**CRONULLA SHARKS DEVELOPMENT, 461 CAPTAIN COOK DRIVE, WOOLLOOWARE, NSW
(MP 10_0229)
EFFECTS OF ELECTROMAGNETIC RADIATION (EMR) FROM 132KV TRANSMISSION LINES
ON THE HEALTH OF FUTURE OCCUPANTS OF PROPOSED RESIDENTIAL, COMMERCIAL
AND RETAIL DEVELOPMENT.**

Response to Sutherland Shire Council's Comments.

Fig.1 Electric field profiles at various distances above ground

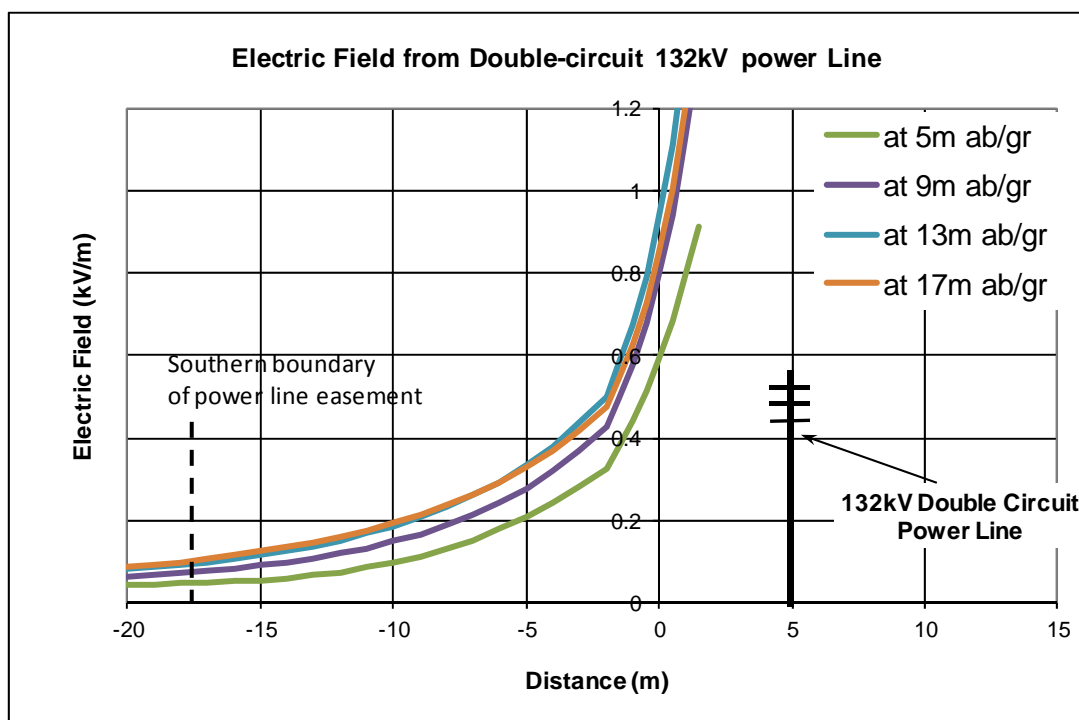
Comment "... it is considered that the electric field calculations contained in the consultant report do not accurately reflect likely exposure. It is recommended that the proponent undertake electric field exposure modelling at the closest, unshielded exposure point and at a point that includes a person standing on an unshielded balcony at the same elevation as the power line."

Response In the report the electric field profile was presented in graphical form at 1m above the ground. This is the standard form of presentation for the electric field across the power line easement. The power frequency electric field as distinct to the power frequency magnetic field is greatly influenced, i.e. distorted and shielded, by all materials including non-electrically conductive materials such as wood, glass, plaster board, brick, stone, trees, shrubs, etc. Therefore, calculating the electric field in free space and extending the results to the case where a person is standing on a balcony of a building adjacent to the power line would be grossly inaccurate. The actual electric field at the position of that person would be much smaller than the calculated electric field in free space. Never the less, we've calculated the electric field profiles in free space at different heights above the ground. The results are presented in graphical form in Fig.1 below.

As can be seen from the graphs in Fig.1 the undisturbed in free air electric field in the area outside the power line easement at heights from 5m to 16m above ground is less than 100V/m. This is considerably less (50 times less) than the allowable exposure limit of 5,000 V/m for the general public (see the table in Section 3.2 of our original report). Taking into consideration also the shielding effectiveness of the building structure and the balcony balustrade, the electric field on the balcony facing the power line easement would be much smaller than the calculated undisturbed electric field in free air.
